UNITED STATES PATENT AND TRADEMARK OFFICE

Application No.	Applicant(s)				
	10/690,421	LARSEN, STEVEN S.	C			
Office Action Summary	Examiner	Art Unit				
	Casey Donahoe	3732				
The MAILING DATE of this communication app Period for Reply	ears on the cover sheet with the c	orrespondence address	5			
A SHORTENED STATUTORY PERIOD FOR REPLY IS SET TO EXPIRE 3 MONTH(S) OR THIRTY (30) DAYS, WHICHEVER IS LONGER, FROM THE MAILING DATE OF THIS COMMUNICATION. - Extensions of time may be available under the provisions of 37 CFR 1.136(a). In no event, however, may a reply be timely filed after SIX (6) MONTHS from the mailing date of this communication. - If NO period for reply is specified above, the maximum statutory period will apply and will expire SIX (6) MONTHS from the mailing date of this communication. - Failure to reply within the set or extended period for reply will, by statute, cause the application to become ABANDONED (35 U.S.C. § 133). Any reply received by the Office later than three months after the mailing date of this communication, even if timely filed, may reduce any earned patent term adjustment. See 37 CFR 1.704(b).

DETAILED ACTION

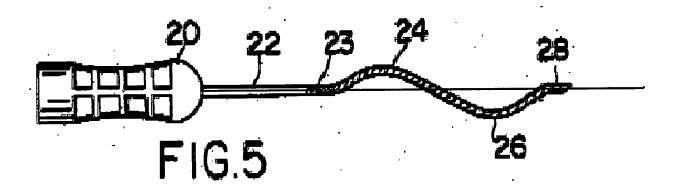
Furthermore, Applicant attempts to distinguish the endodontic file of the present invention from that of Lovaas by stating that the file only crosses the centerline once. However, as can be seen from the drawing below, the file of Lovaas only crosses the center line once then barely returns to the centerline without crossing it again.
